INDESIT company

Model type:
DI620

Commercial code:
F029931

Notices

N1045083FIG1

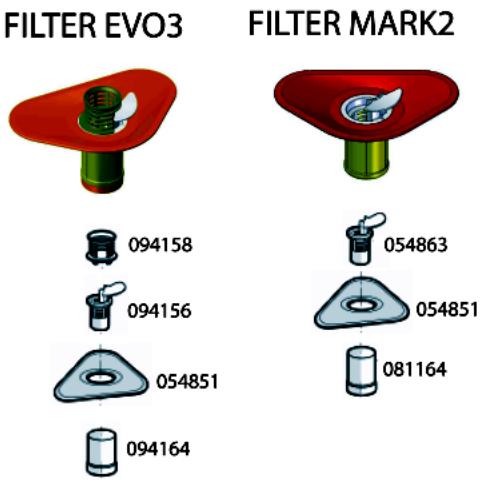
n1045083: Modification of filters on EVO3 60 cm dishwashers

All dishwasher models affected by this modification have been equipped with the items listed below, in order to solve the drain pump clooging problem.

Introduction of:
Cylindrical plastic filter code 081164
Central filter code 054863

Elimination of:
Cylindrical plastic filter code 094164
Central filter code 094156
Central filter grid code 094158

The modification has been introduced progressively, starting from serial no. 40516.0001.

n1045085: Introduction of new litre counter turbine integrated on air-break.

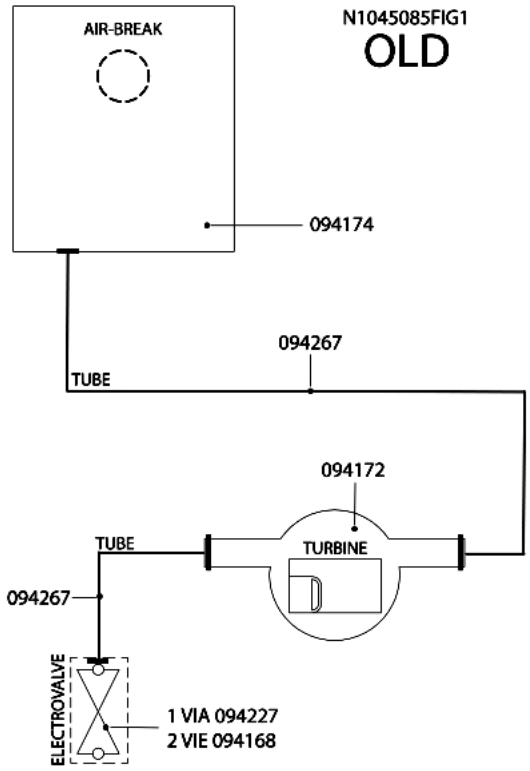
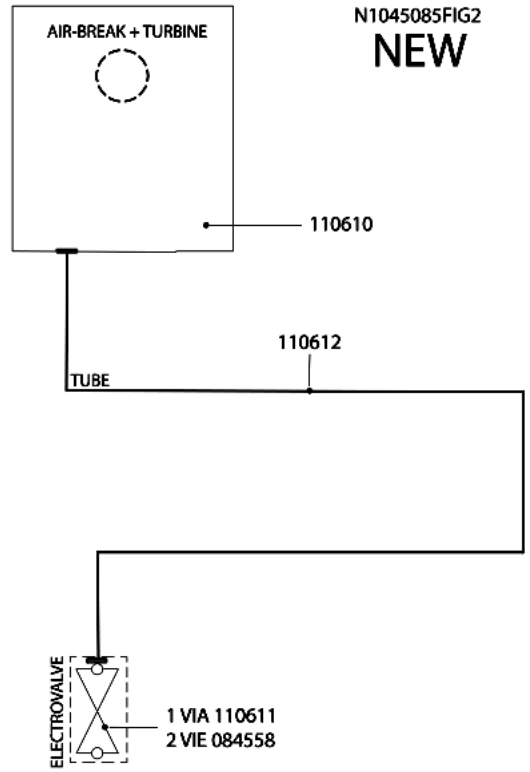
All dishwashers affected by this note have been equipped with a new litre counter turbine on the air-break.
Picture N1045085FIG1 illustrates the premodification structure, picture N1045085FIG2 the new structure.

Items affected by the modification.

AIR-BREAK:
new 110610;
premodification 094174;
the new item features a new integrated litre counter turbine and its water supply hose has a smaller diameter.

LITRE COUNTER TURBINE code 094172 has been eliminated.

SOLENOID VALVES:
new:
1-WAY code 110611;
2-WAY code 084558(Rohs 143737);
premodification:
1-WAY code 094227;
2-WAY code 094168;
the new solenoid valves have a smaller diameter drain hose fitting.

HOSES:
new solenoid valve hose/air-break code 110612;
premodification turbine hose/air-break code 094267;
premodification solenoid valve hose/air-break code 094267;
the new hose has a smaller internal diameter.

WIRING:
the litre counter turbine connecting cable is longer, but since the connector is the same, the new item can be used in place of the premodification one.

N1045076FIG1

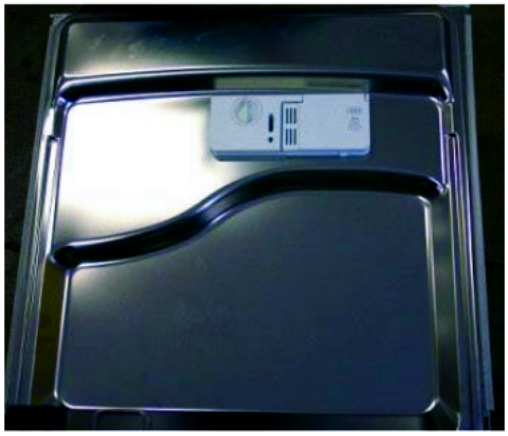
n1045098: Different position of electric distributor.

The position of the electric distributor has been changed as shown in the attached illustration.
The new machines have a new industrial code.

Introduced items:
C00109659 upper rack
C00109698 inside door

Premodification items:
C00097164 upper rack
C00095276 inside door

N1045133/134FIG1

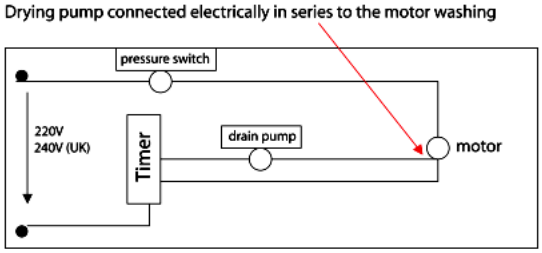
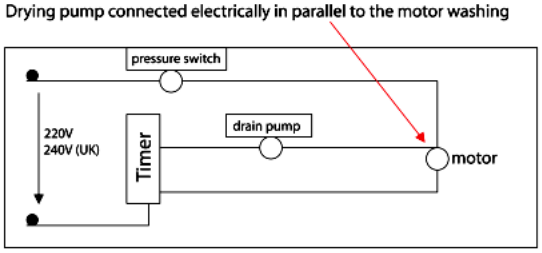
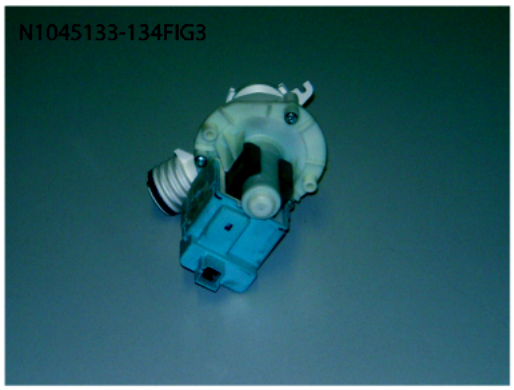
n1045133: New thermoprotected drain pump in parallel with wash electric pump

The drain pump electrical connection has been modified from a configuration in series with the wash electric pump to one in parallel.

The drain pump in series with the wash electric pump is fed through the wash electric pump causing a voltage drop equal to -15V (diagram N1045133-134FIG1).

The drain pump in series with the wash electric pump is electrically fed directly by the F-N line, without any voltage drop (diagram N1045133-134FIG1).

New parts:
Wiring in parallel
C00118767(Rohs 143766) - thermoprotected drain pump 220/240V 50HZ 26W - picture (N1045133-134FIG3)

Premodification parts:
Wiring in series
C00112306(Rohs 143739) - drain pump 230V 50HZ 22W - picture (N1045133-134FIG4)

Important!!
The thermoprotected drain pump cannot be installed on premodification dishwashers.
The non-thermoprotected drain pump cannot be installed on modified dishwashers.

N1045136FIG1

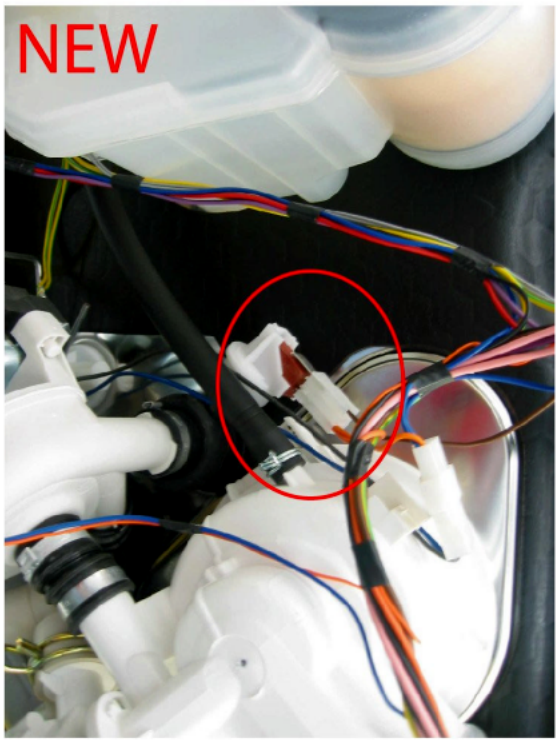
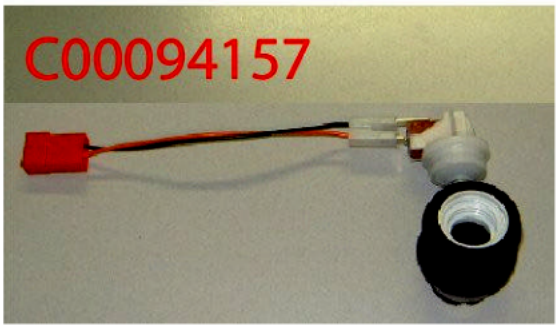
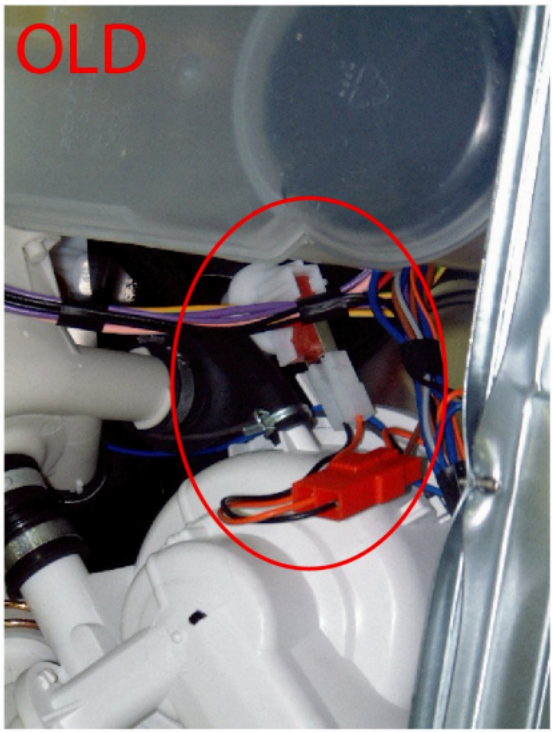
n1045136: introduction of new high pressure sensor

In modified products the connector going to the high pressure sensor is part of the wiring assembly (see picture N1045136FIG1).
In premodification products the high pressure sensor is connected to the wiring assembly by a cable that is part of code C00094157 (see pictures N1045136FIG2-3).

New parts
Wiring
C00142435 - high pressure sensor

Premodification parts
Wiring
C00094157 - high pressure sensor + cable

The new parts are not individually interchangeable with premodification ones.
